DRB RECOMMENDATION MEETING

## The 8 Tower Seattle, WA

3025536

CARON REF #2016.049

##### 3. Streetscape.

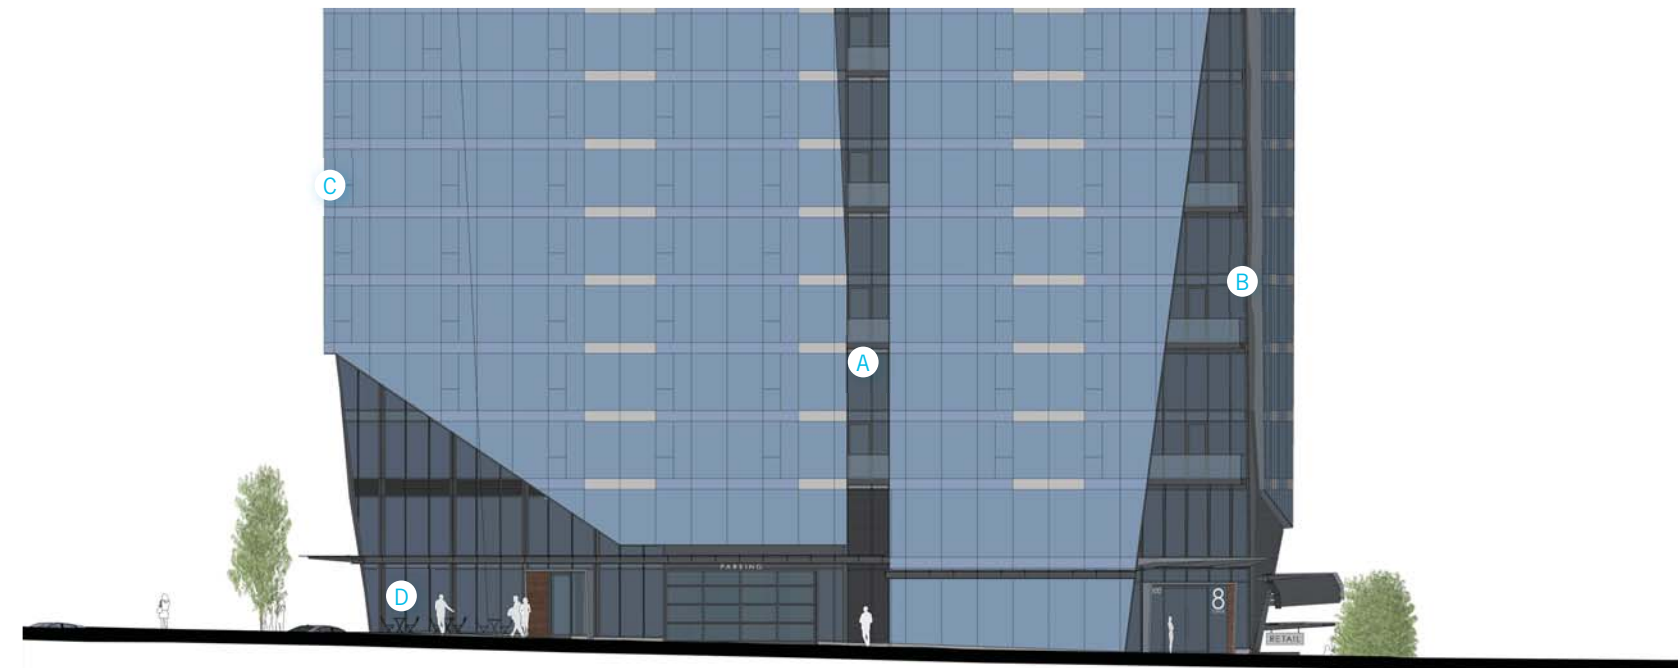
- The Board felt the manner and shape in which the skin was pulled up at the base of 8th and Bell was very successful. The Board encouraged using this same strategy around the rest of the building (B4).

##### 3. Streetscape.

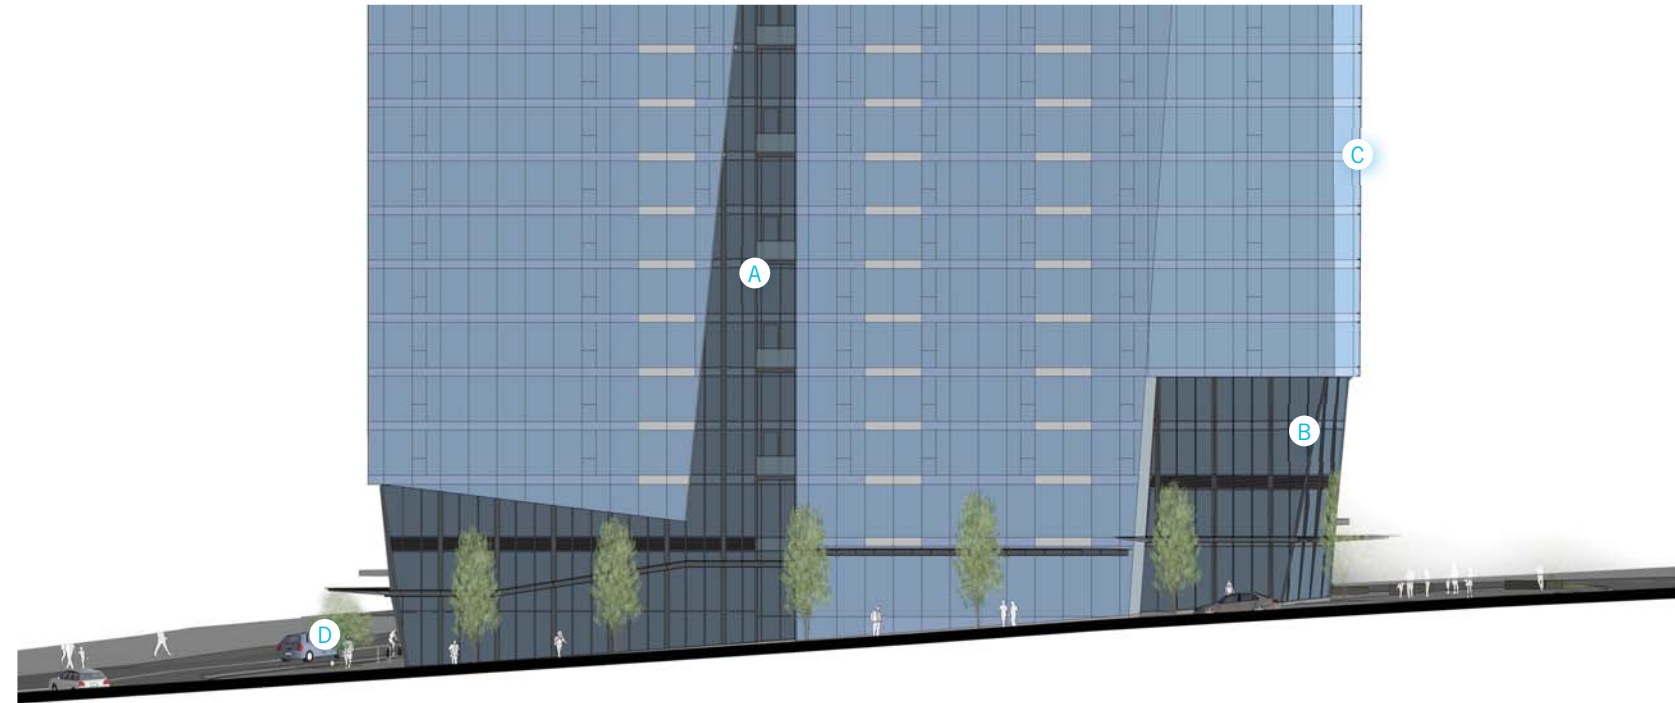
- The Board felt the manner and shape in which the skin was pulled up at the base of 8th and Bell was very successful. The Board encouraged using this same strategy around the rest of the building (B4).

CANOPY VIEW

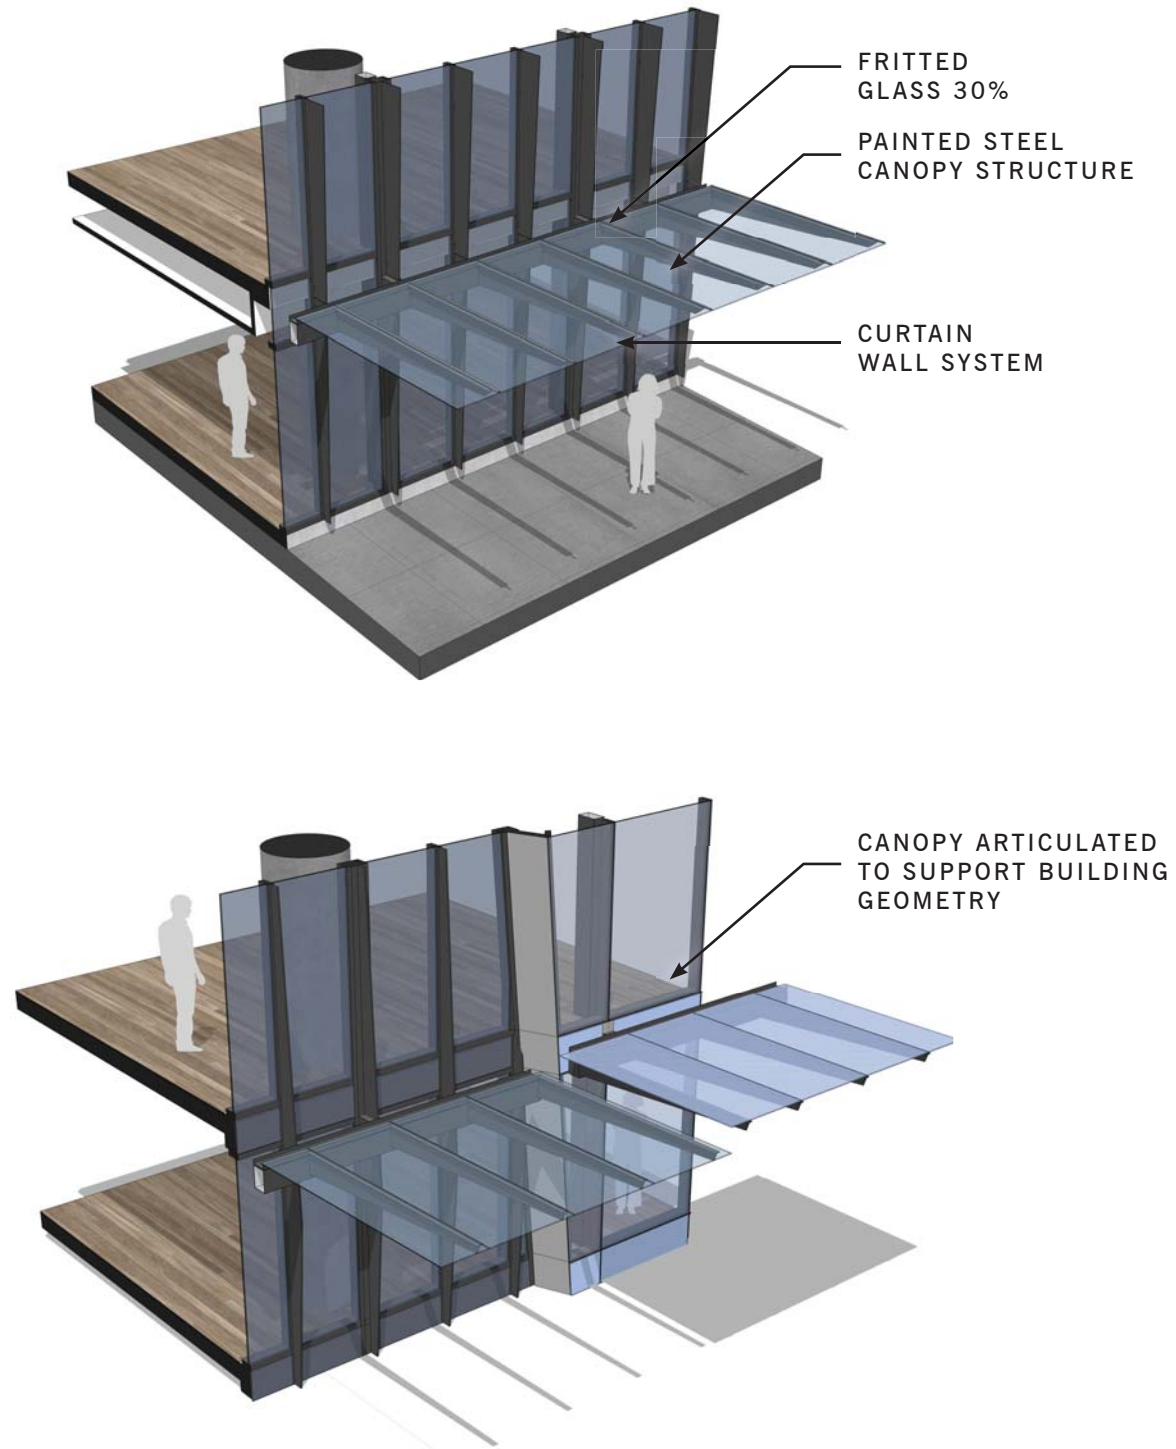
- The Board acknowledged public comment about the overhead canopies and agreed that the design of these canopies should not detract from the concept of the tower meeting the base directly with forms that erode and peel back from the tower skin. The canopies should be designed as glassy and frameless elements that provide overhead weather protection, but blend seamlessly into the building design without breaking the concept with an abrupt horizontal projection or detract from the subtractive quality of the base design (B4, C5.1).
- The Board also noted that the shape, form and height of the canopies should be irregular and faceted to reinforce the design concept (B4, C5.1).
- The Board agreed with public comment that the integration of the Bell Street Concept Plan into the design of this streetscape was very positive (B3.3, C1.3).

Overhead canopies are integrated with the tower base “reveal” while modulated to work with sidewalk grade and provide maximum protection over sidewalks. Canopies are simplified for a glassy look and frameless edge toward the streets with fritted glass and articulated to compliment facade geometries. A prominent canopy was added to the residential entry to make it clearly identifiable. Canopies are sloped toward the building to protect pedestrians on sidewalks from dripping water.

CORNER OF 8TH AVENUE & DENNY WAY

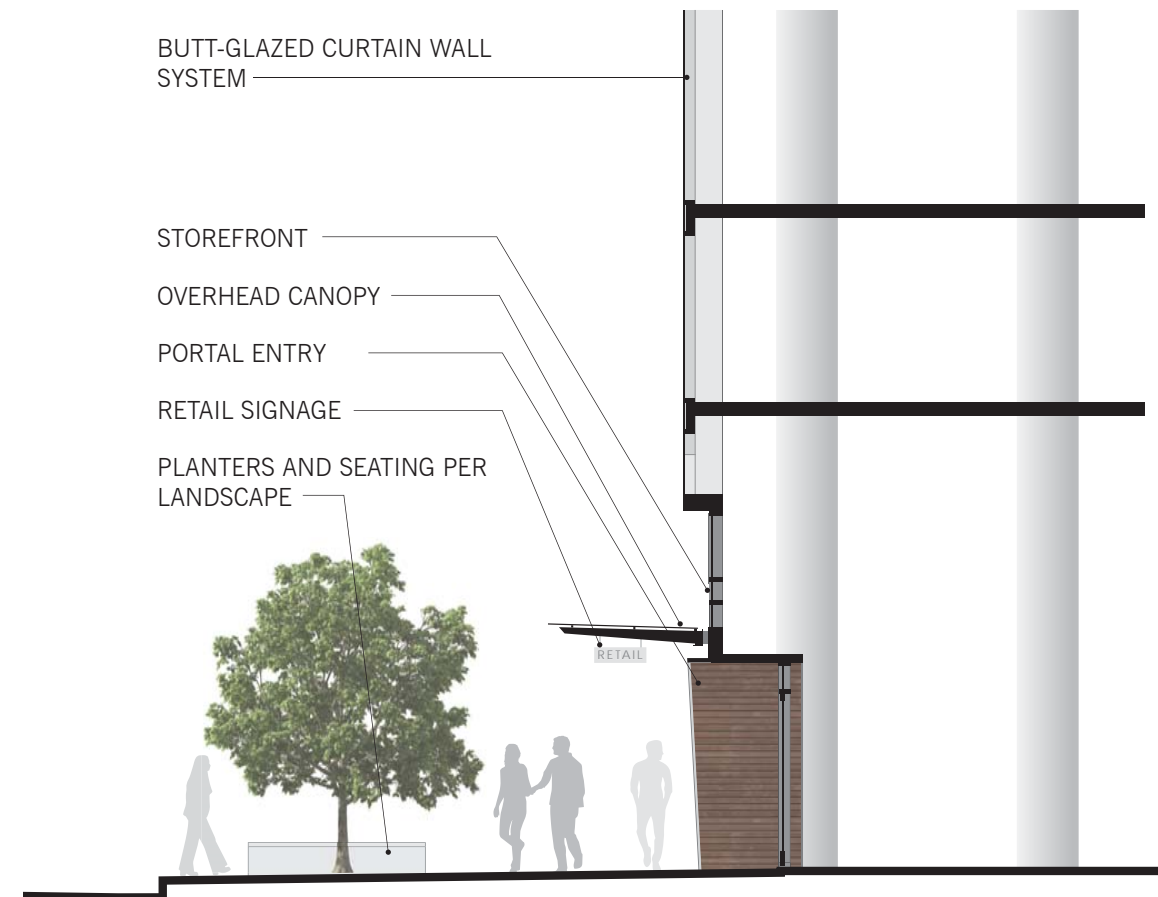
- The Board echoed public comment in support of the setback building corners, opening up the ground plane for physical and visual circulation for pedestrians (B3.3, C1.3).
- The Board was supportive of the landscape design concept and agreed with public comment that each of the three corners should be designed with a distinct language and expression that responds to the unique conditions of each corner (B1, B3.3, C1.3).

CORNER OF DENNY WAY & BELL STREET

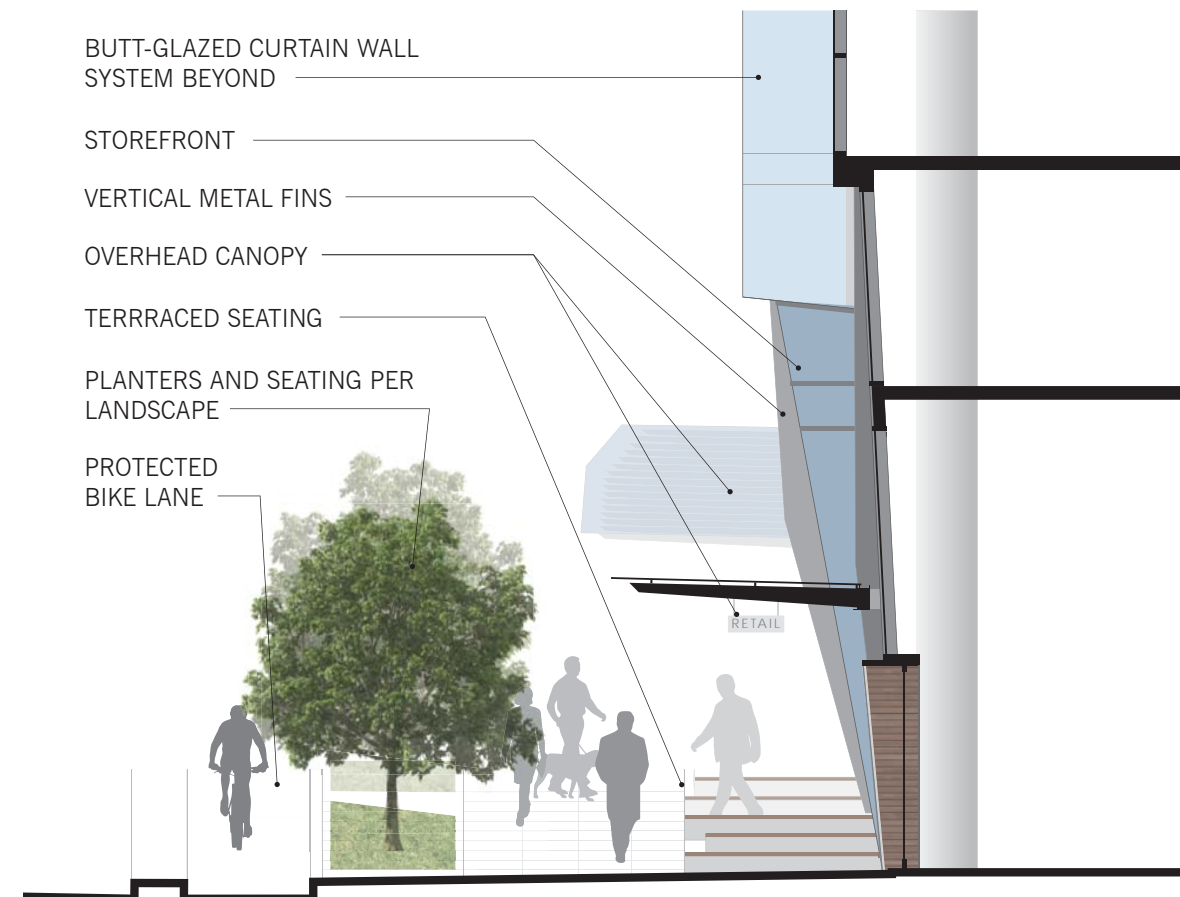
- The Board echoed public comment in support of the setback building corners, opening up the ground plane for physical and visual circulation for pedestrians (B3.3, C1.3).
- The Board was supportive of the landscape design concept and agreed with public comment that each of the three corners should be designed with a distinct language and expression that responds to the unique conditions of each corner (B1, B3.3, C1.3).

CORNER OF 8TH AVE & BELL ST.

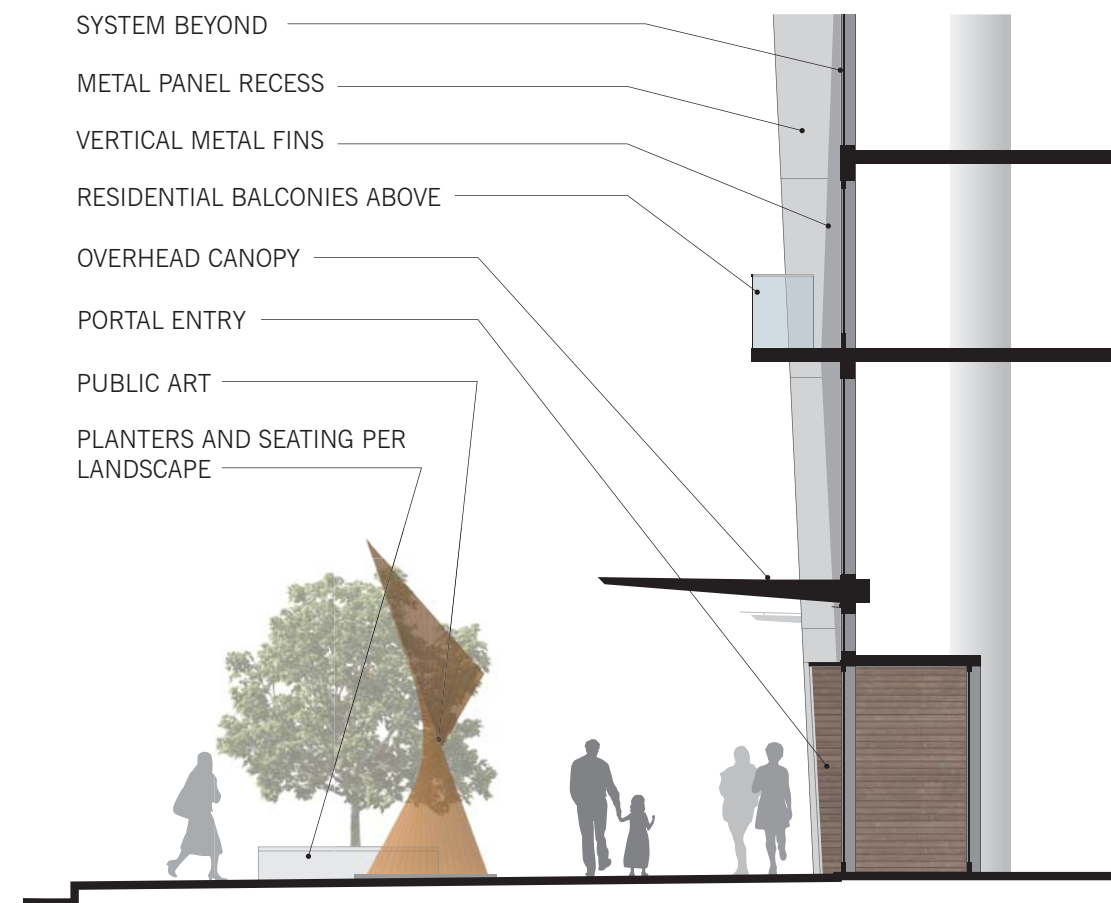
- The Board echoed public comment in support of the setback building corners, opening up the ground plane for physical and visual circulation for pedestrians (B3.3, C1.3).
- The Board was supportive of the landscape design concept and agreed with public comment that each of the three corners should be designed with a distinct language and expression that responds to the unique conditions of each corner (B1, B3.3, C1.3).
